# ATTACHMENT 7 - Landscape plan

project  
PROPOSED SUBDIVISION LOT 1301-1304  
DP1236986 MARSH ROAD, SILVERDALE

dwg title  
LANDSCAPE FEATURES PLAN

dwg no.  
LC01/02F

## LANDSCAPE FEATURES PLAN 1:1200

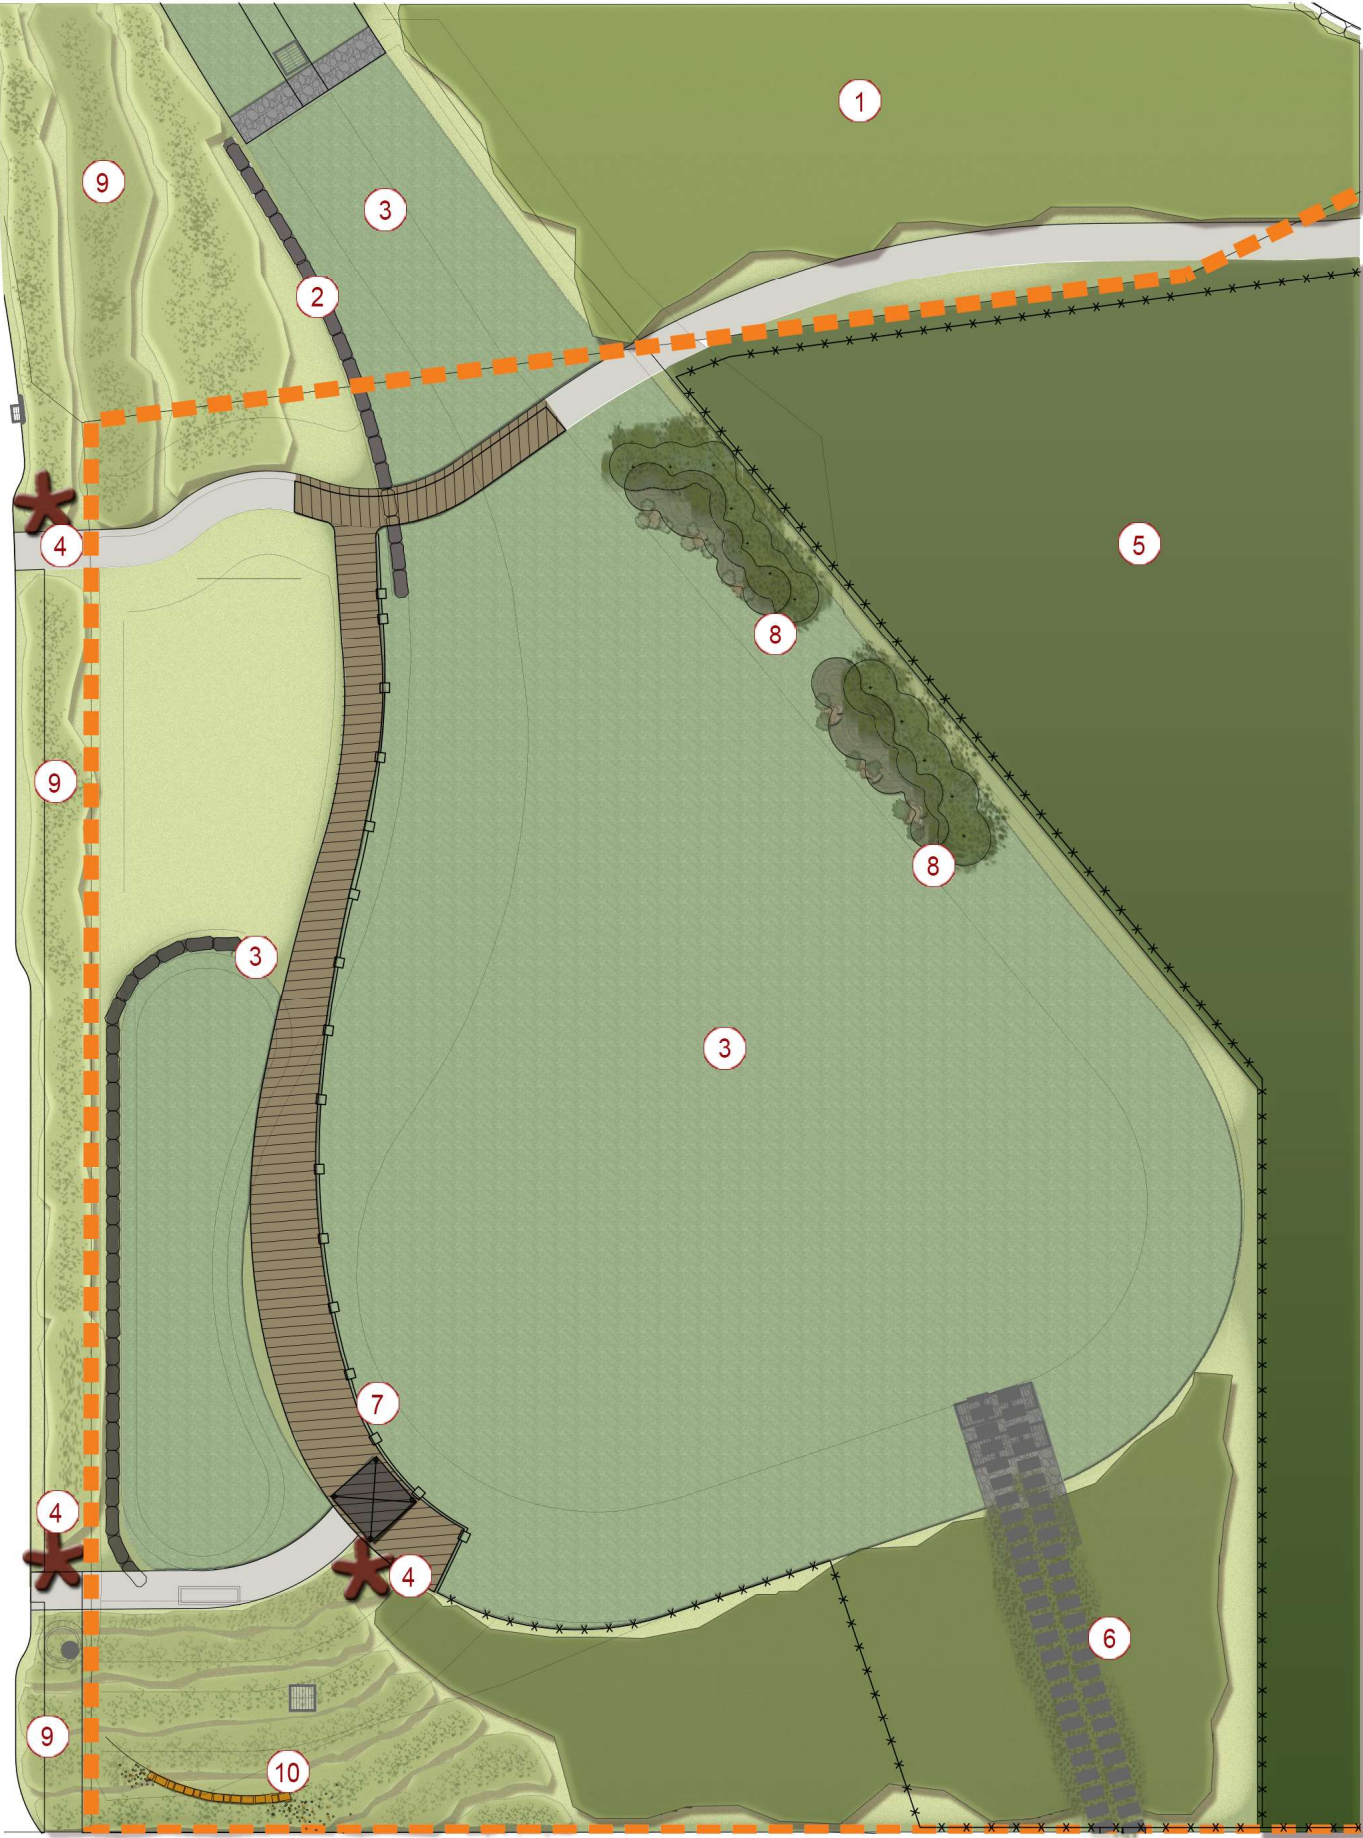
AMENDMENTS AFTER COUNCIL MEETING:

- A Footpath along northern side of Production Avenue to connect to existing pedestrian entry to Warragamba reserve. Internal connections to playground & fitness stations provided by Council.
- B Smaller scale entry feature with reference to Lion Park.
- C Endemic planting around signage.
- D No timber to be used for any structures. Steel framework for all structures including shelter structure. Council mentioned: 'Replas' decking.
- E Installation of bollards to minimise access to upgraded landscape areas. 700mm wide strip along kerb to be planted out to minimise Council maintenance.
- F Provide footpath connection along access road.
- G Playground to include: swing, slide & climbing structure. Mature trees to provide shade. No shade structure. Include bike racks & park furniture.
- H Walkway/cycleway with turfed edges. No garden beds. Restricted street tree planting.
